St. Johns River

Water Management District

DATE: February 13, 2019
TO: Prospective Respondents
FROM: Amy Lucey, Procurement Specialist
SUBJECT: Addendum #4 to IFB # 34093, C40 Plugs Enhancements

Figure 1: General location of borrow

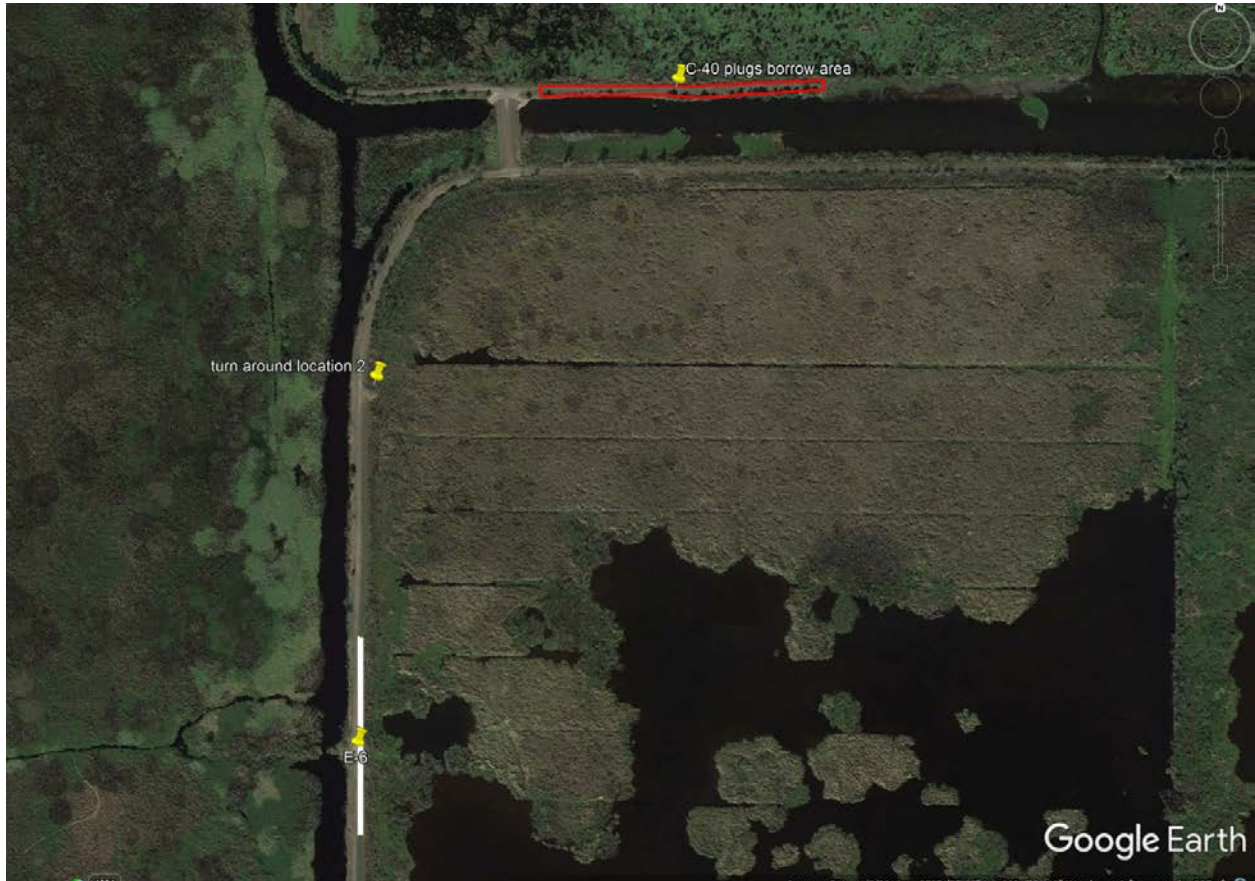
Q21: It is our understanding that suitable Owner furnished backfill materials exist north of the project sites and will be available to the Contractor for this project, so no Contractor imported fill is required. Please confirm this is correct and provide this location on a map and the allowable cut area and depth.

- A21: As discussed at the site visit on February 6, 2019, the District believes there is ample suitable fill in the remnant levee located along the north side of the S-256 flowway. The borrow area is approximately 850' long and width ranging from 15' at the top to 30' near the water. The top of the remnant levee is 3'-4' above the water level. The contractor may take material down to the water level. If borrow is needed from this area, the specific boundaries will be staked by District staff. The borrow area is approximately 0.2 miles from turn around 2. Any damage to the haul route during the borrow activity must be restored to existing or better condition. See Figure 1: General location of borrow in the Appendix section.
